Access Compliance Report

Public Rights-of-Way

Intersection ID: 13600	Main Street: 3RD-4TH_CONNECTOR_ST	Cross Street: E_4TH_ST	Location: E
ADA ID: 7993AC2A319D	Ramp Type: Perp	Initial Pass/Fail: Fail	Overall Compliance: No
Severity Score: 8.75			
Codes/Mitigation Info/Possible Solution		Field Measurements/Component Compliance

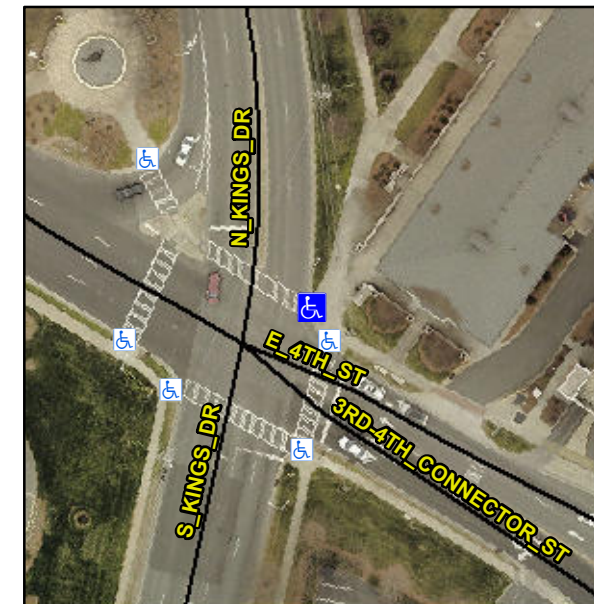
Not Found, R304.5.1

Compliance	Description	Data	Compliance	Description	Data
N/A	Ramp Length (in)	75.0	Yes	Ramp Slope (%)	7.5
No	Ramp Width (in)	47.0	Yes	Ramp XSlope (%)	0.2
N/A	Flare Type LT	N/A	N/A	Flare Type RT	N/A
N/A	Flare Slope LT (%)	N/A	N/A	Flare Slope RT (%)	N/A
N/A	Flare Traversable LT?	N/A	N/A	Flare Traversable RT?	N/A
N/A	Landing Length (in)	N/A	N/A	DWS Provided?	N/A
N/A	Landing Width (in)	N/A	N/A	DWS Contrast?	N/A
N/A	Landing Slope (%)	N/A	N/A	DWS Length (in)	N/A
N/A	Landing X Slope (%)	N/A	N/A	DWS Full Width?	N/A
N/A	Landing Curb? (Y/N)	N/A	N/A	DWS Offset (in)	N/A
N/A	Shared Landing?	N/A			
N/A	Gutter Ponding?	N/A	N/A	Gutter Slope (%)	N/A
N/A	Gutter Lip Ht (in)	N/A	N/A	Gutter X Slope (%)	N/A
N/A	Painted X Walk1?	Yes	N/A	Painted X Walk2?	N/A
	X Walk 1 Direction	To NW		X Walk 2 Direction	N/A
N/A	X Walk 1 Width (in)	105.0	N/A	X Walk 2 Width (in)	N/A
	X Walk 1 Slope (%)	2.1		X Walk 2 Slope (%)	N/A
	X Walk 1 X Slope (%)	1.6		X Walk 2 X Slope (%)	N/A

Remove & Replace Entire Ramp.
